LAUREN A. WASILAUSKI
Open Space & Stewardship
Director

MEMORANDUM

To: Zoning Board
From: Lauren A. Wasilauski, Open Space & Stewardship Director
Date: March 20, 2024
Re: BA-04-23 Renard Management, LLC
Block 29002 Lots 49 & 50 (1026 County Route 518)
Preliminary and Final Major Site Plan with Use and Bulk Variances

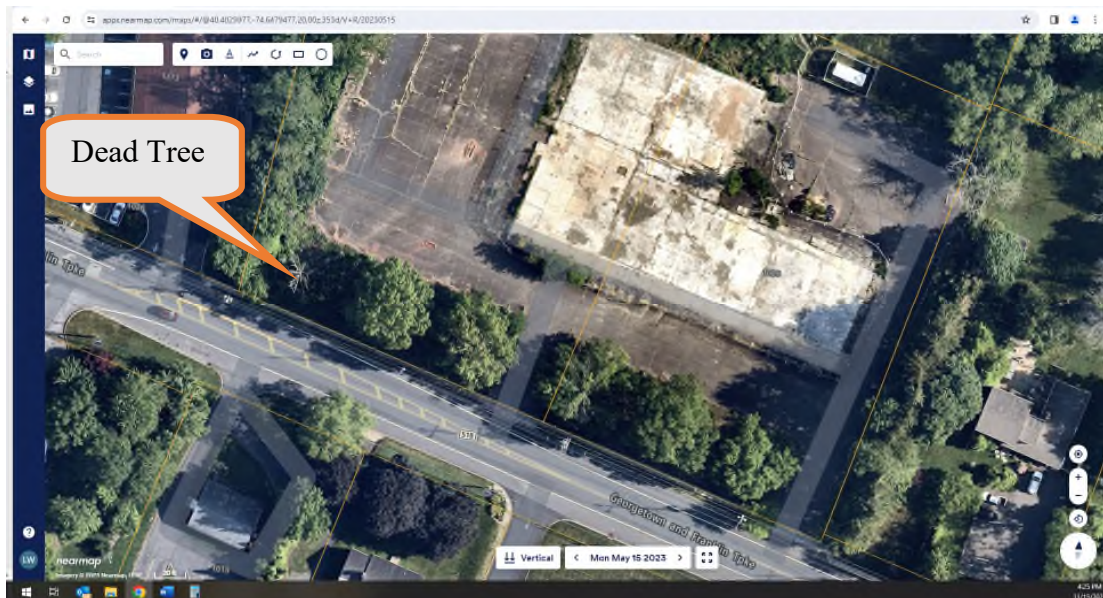
- a. A note has been added to sheet 4 to reflect this Code provision.
- 3. In looking at recent NearMap imagery, it appears that pedestrians (and possibly cyclists) are cutting through the subject property to access the Montgomery Shopping Center (see screen grab from May 15, 2023 on the following page).

- a. This office suggests the Applicant explore adding pedestrian accommodations through their property, and working with Hilton Realty of Montgomery Shopping Center to formalize this pedestrian access.
